Ventura County Community College District

DATE: March 22nd, 2024
TO: All Bidders
FROM: David Cienfuegos, Purchasing Specialist
SUBJECT: Addendum 1 – Bid 669, Ventura College Parking Lot Maintenance Rebid

MCE STAFF PARKING LOT TYPICAL LAYOUT

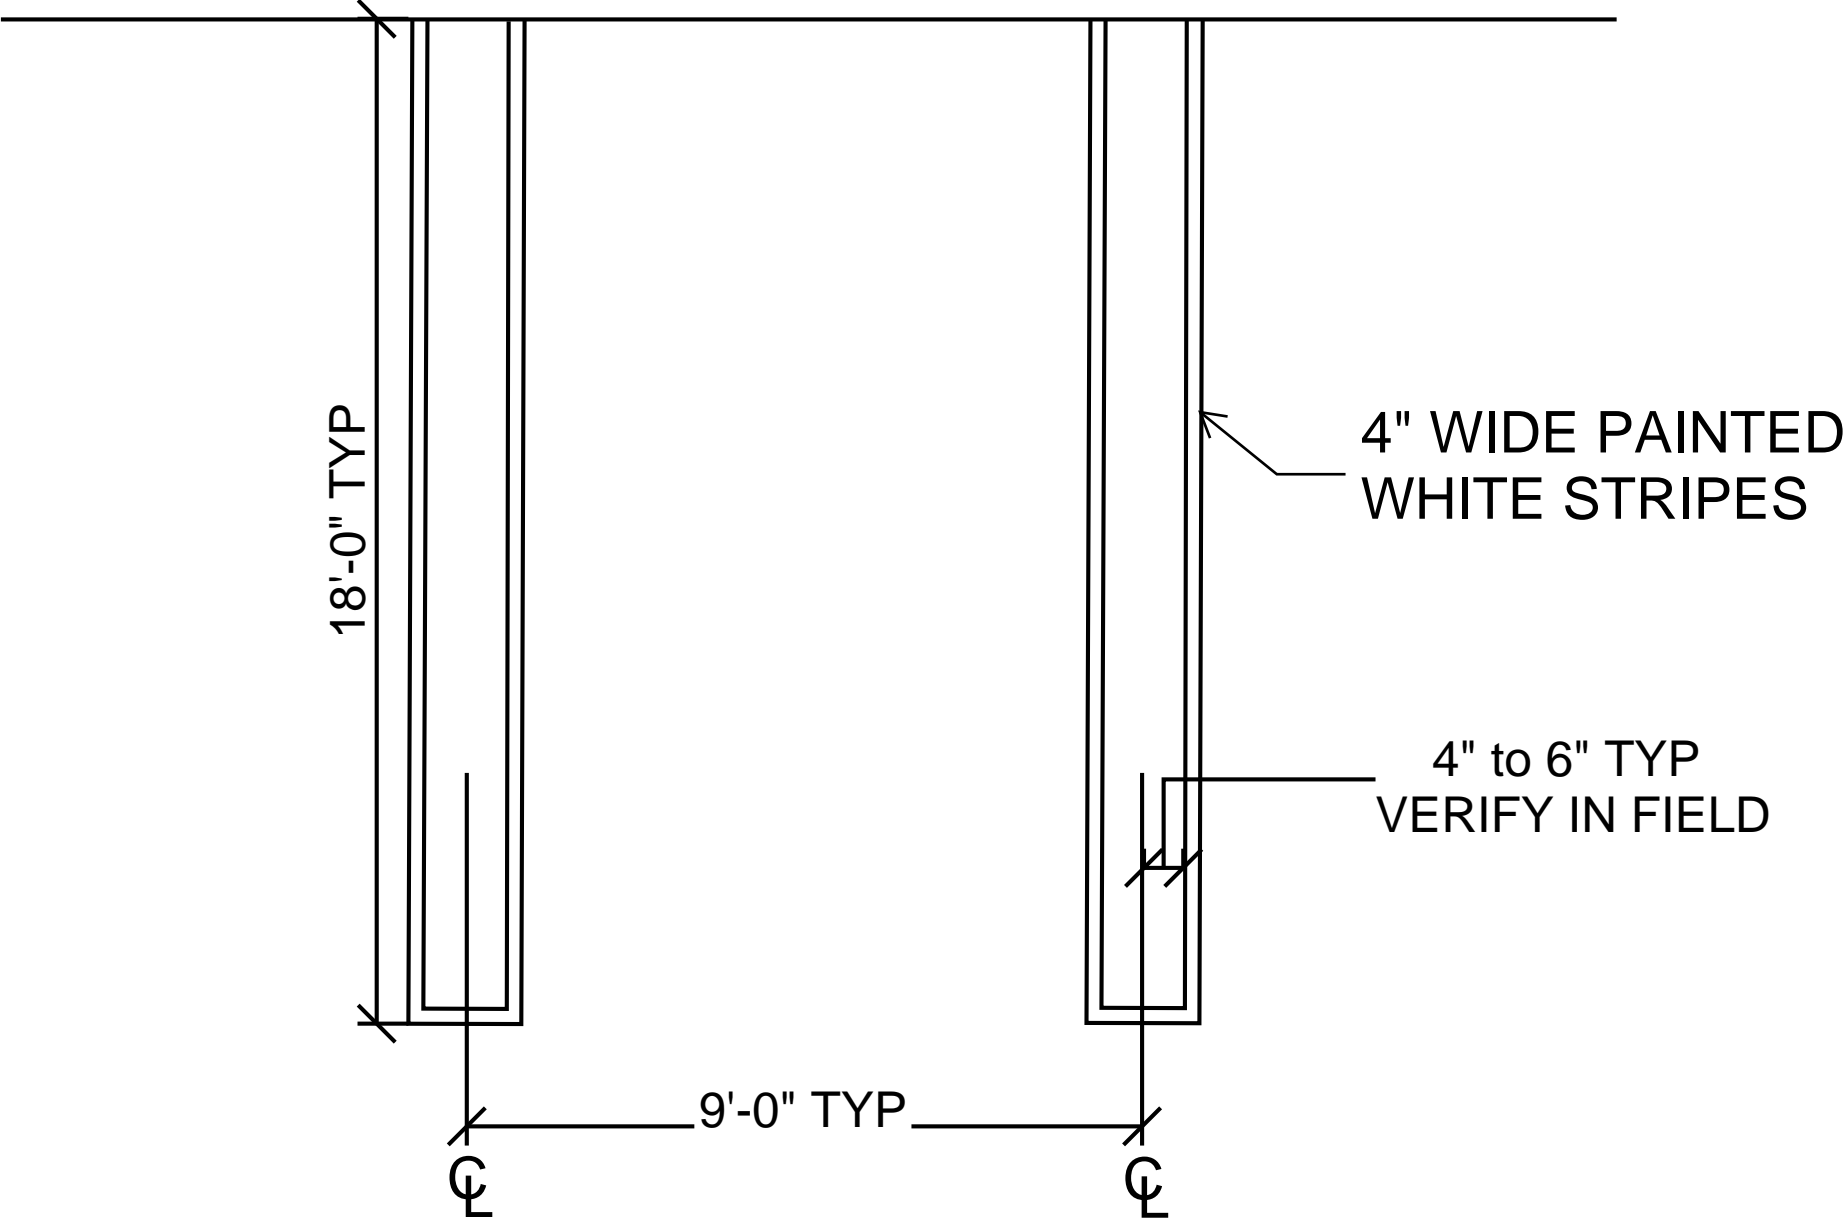
1. What is the engineer’s estimate for this project?
 - a. There is no engineer’s estimate, however the estimated cost for this project is approximately \$200,000.
2. Are there clear plans for the striping for the MCE Staff Lot?
 - a. There are (18) parking lots stalls within “STAFF” markings. Reference the attached typical layout and pictures for some clarity of the MCE Staff Lot. The Contractor is responsible for noting the existing conditions to seal and restriping the parking lot as previously designed.
3. Has the scope of work changed since the previous bid?
 - a. The previous bid originally had (8) parking lots in the scope of work. Bid 669 reduced it down to (6) parking lots across Ventura College, reference Scope of
